ISSUE	DATE	DRAWN	CHECKED	DESCRIPTION
DRAWING TITLE	GA PROPOSED BIDBOROUGH STREET ELEVATION			
DRAWING NO.	CTH-PUR-MP-ZZ-DR-A-92102			
REVISION	P01			
SIZE & SCALE	A1L 1:200			
DRAWING STATUS	Issued for Planning

CLIENT	Lendlease
PROJECT	Camden Town Hall
JOB NUMBER	238664

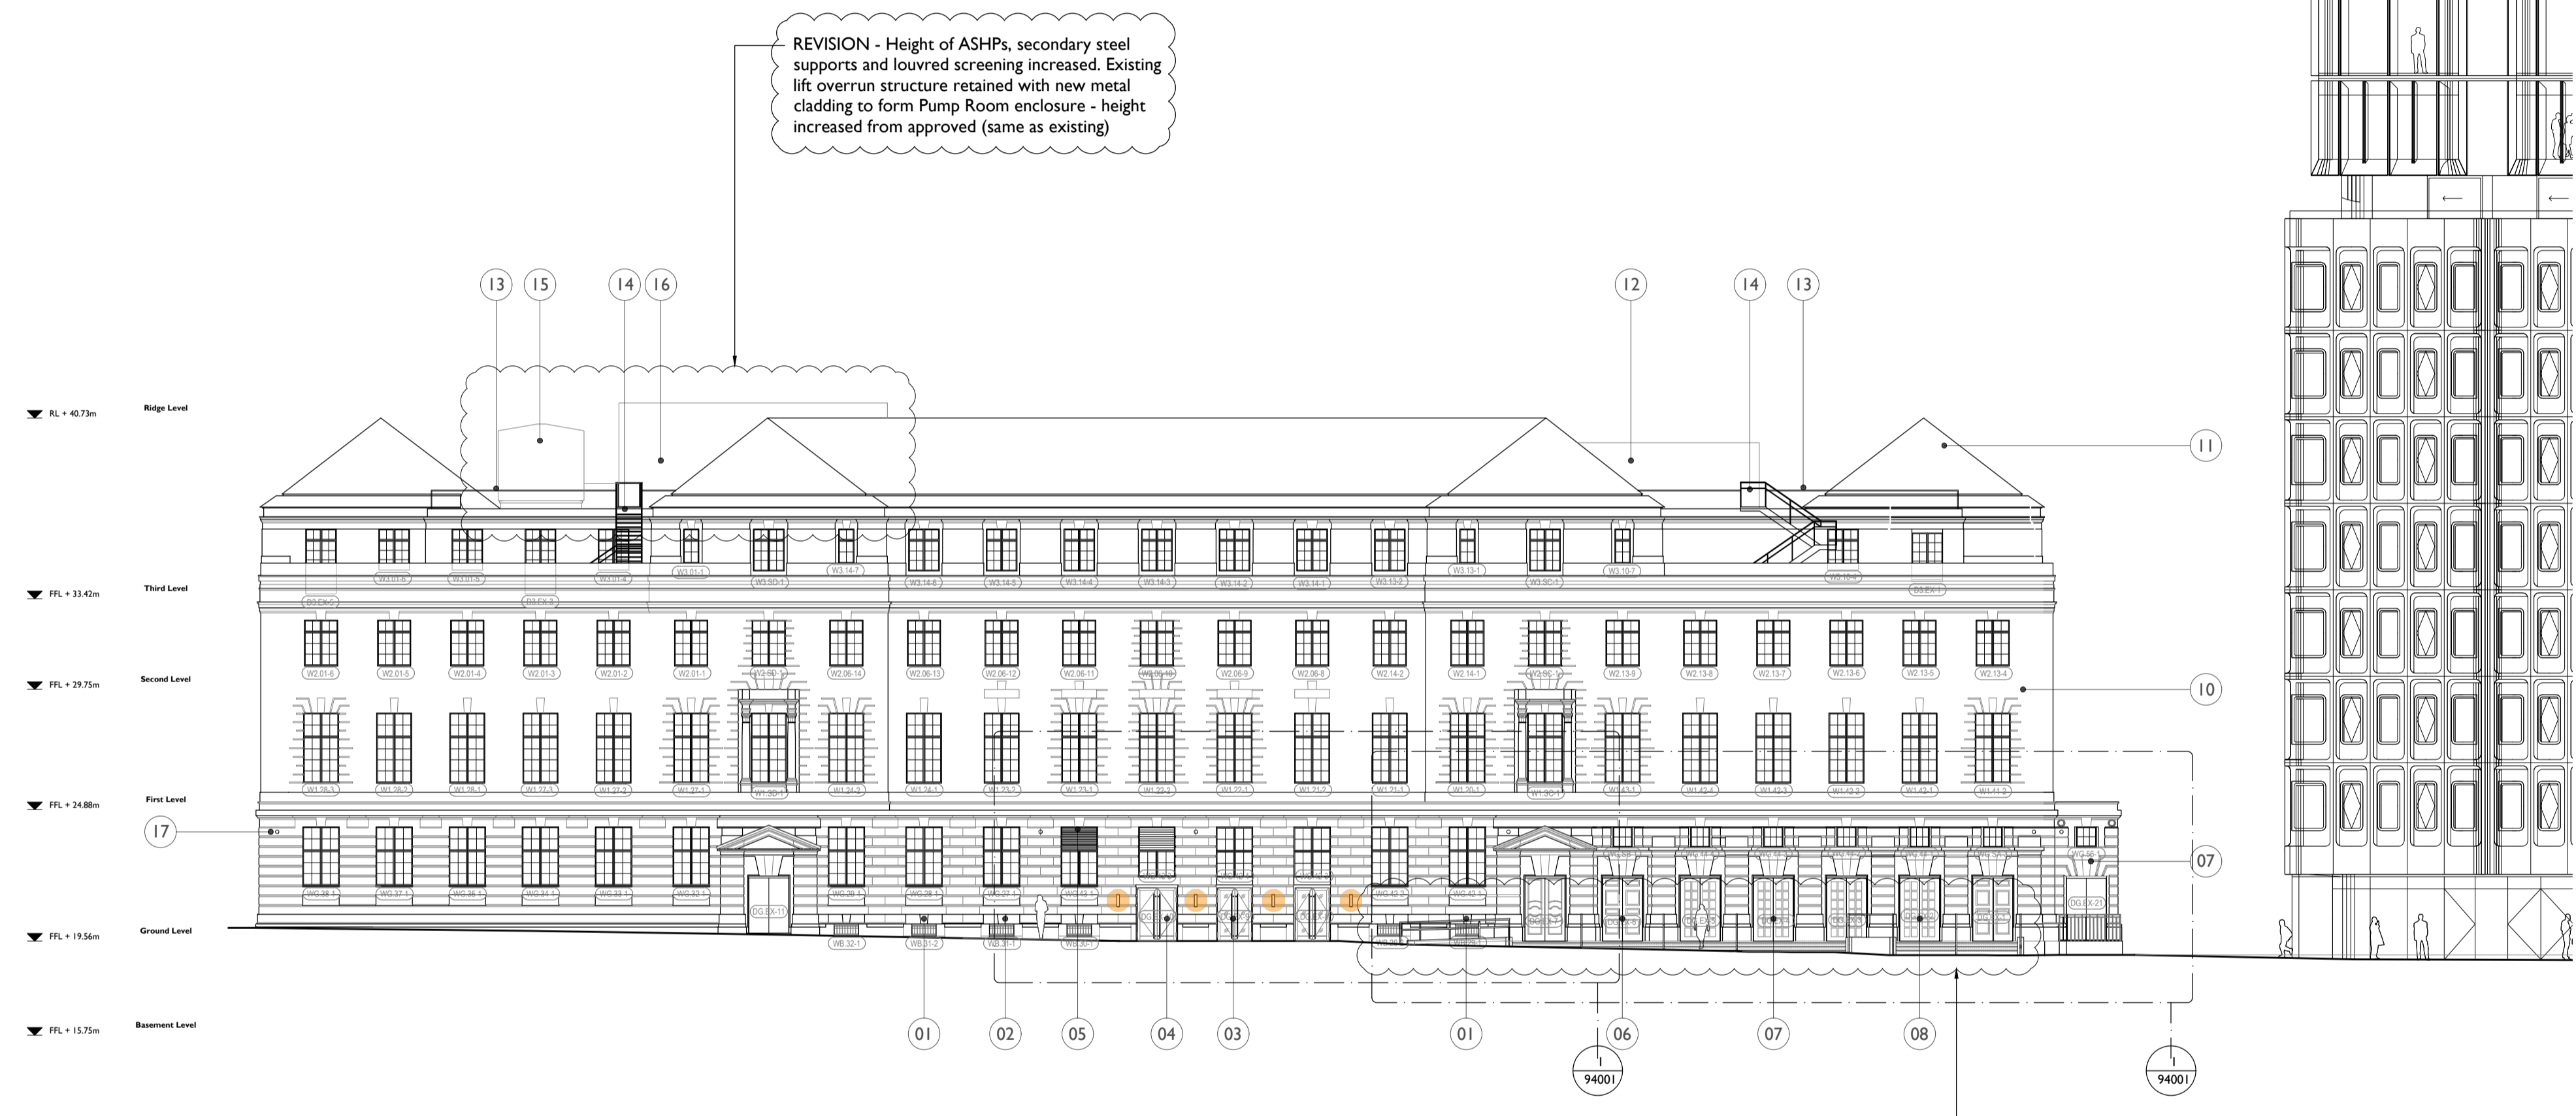
REVISION - Height of ASHPs, secondary steel supports and louvred screening increased. Existing lift overrun structure retained with new metal cladding to form Pump Room enclosure - height increased from approved (same as existing)

REVISION - New hard landscaping amended to suit existing levels and improve accessibility
